Response to
Request for Additional Information No. 265, Supplement 5

U. S. EPR Standard Design Certification
AREVA NP Inc.
Docket No. 52-020
SRP Section: 03.06.03 - Leak-Before-Break Evaluation Procedures
Application Section: 03.06.03

QUESTIONS for Component Integrity, Performance, and Testing Branch 1
(AP1000/EPR Projects) (CIB1)

Figure 3.6.3-6—Minimum Moment versus Circumferential ~~Leakage~~ Crack ~~Leakage~~ Sizes for 5 gpm at ~~Two~~ ~~hree~~ Surge Line Locations

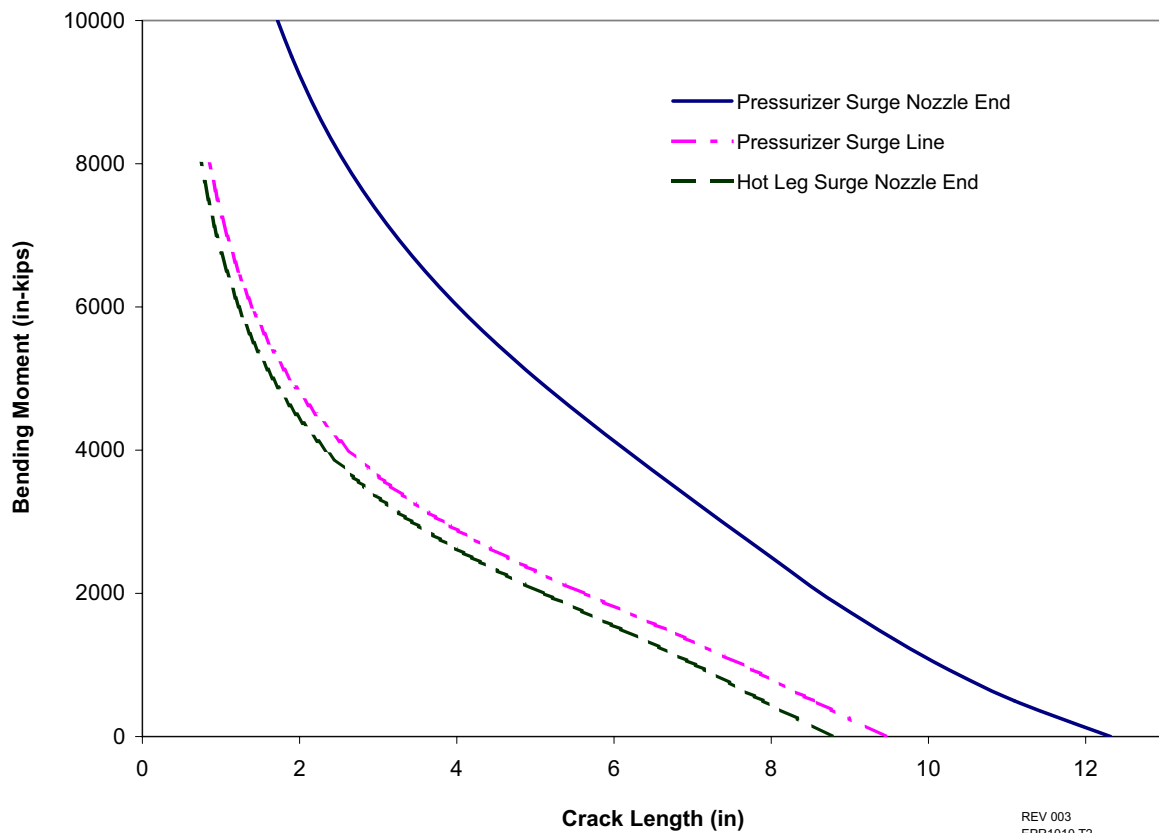
- U.S. EPR FSAR Tier 2, Figure 3.6.3-6 will be revised to add an additional location (i.e., the remainder of the pressurizer surge line) and to reflect the revised fatigue (air) crack morphology. This information is provided in tabular form in revised U.S. EPR FSAR Tier 2, Table 3.6.3-10.

Figure 3.6.3-18—ALL for Pressurizer Surge Nozzle at Alloy 52 Weld

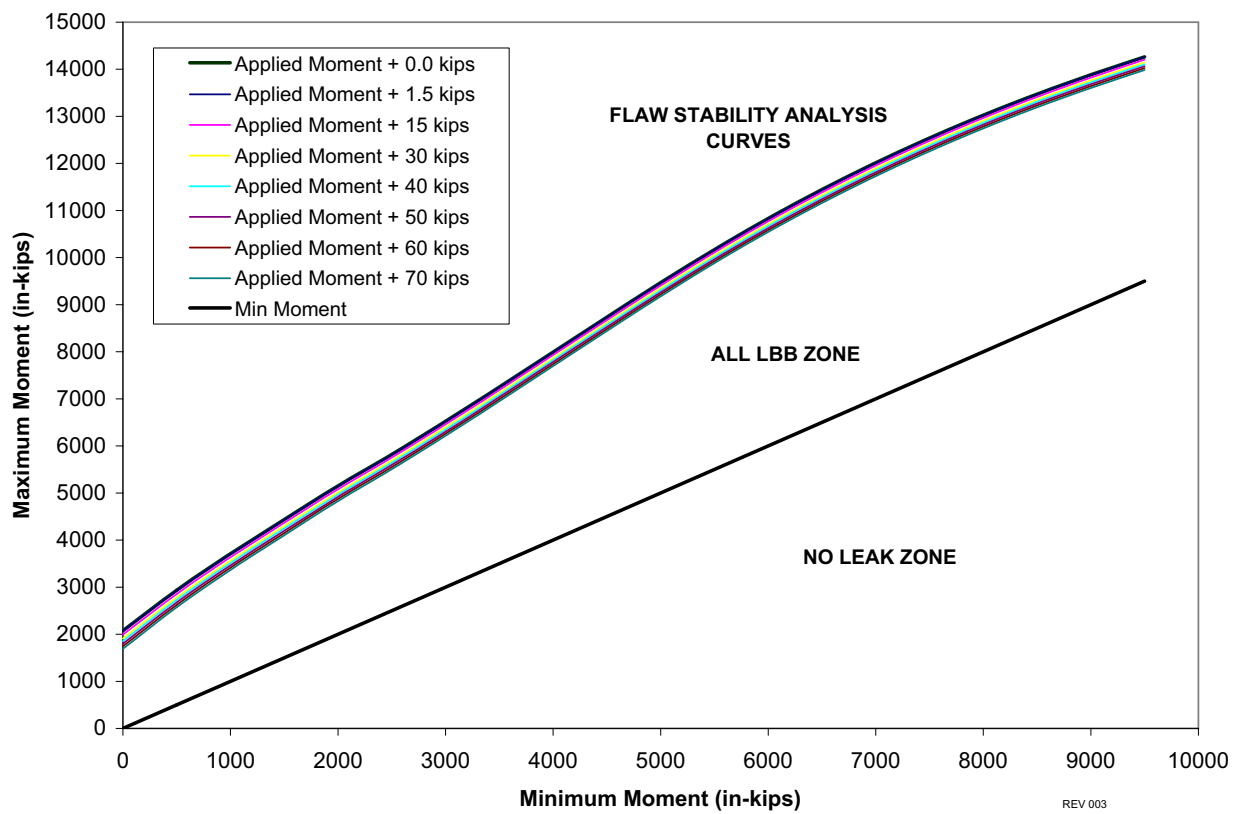
The FE analysis was carefully performed and the equivalent material properties obtained look fine. Sensitivity studies showing that the equivalent properties are nearly independent of crack size were performed. Analysis using both AREVA codes and the NRC code, NRCPIPE,

validated the solutions obtained. The estimates for J using modified GE/EPRI and LBB.ENG2 are very close, which shows validation of the method in Figure 5 of Attachment 2 of the RAI 265 supplement. AREVA did a careful job developing the ALL diagrams using both AREVA and NRC type methods. This provides a good check and appears well done.

Based on the analysis the NRC requests that AREVA redo all the ALL diagram calculations based on the approach identified above.

U.S. EPR FSAR Tier 2, Figures 3.6.3-18, 3.6.3-19, and 3.6.3-20 will be revised to update the allowable load limit (ALL) diagrams as requested in the above NRC Comment on the original AREVA NP Response to Question 03.06.03-26. The revised ALL diagrams that are in revised U.S. EPR FSAR Tier 2, Figures 3.6.3-19, and 3.6.3-20 also provide results at additional SL locations and also reflect that the leak rate analysis considers fatigue (air) crack morphology with applicable number of turns and roughness values reported in NUREG/CR-6004. Additional U.S. EPR FSAR changes that reflect these revised figures and the leak-before-break (LBB) methodology described in References 1 through 9 are as follows:

- U.S. EPR FSAR Tier 2, Table 3.6.3-21, Table 3.6.3-22, and Table 3.6.3-23 will be revised to include the revised tabulated results for the ALL diagrams depicted in U.S. EPR FSAR Tier 2, Figure 3.6.3-18, Figure 3.6.3-19, and Figure 3.6.3-20.
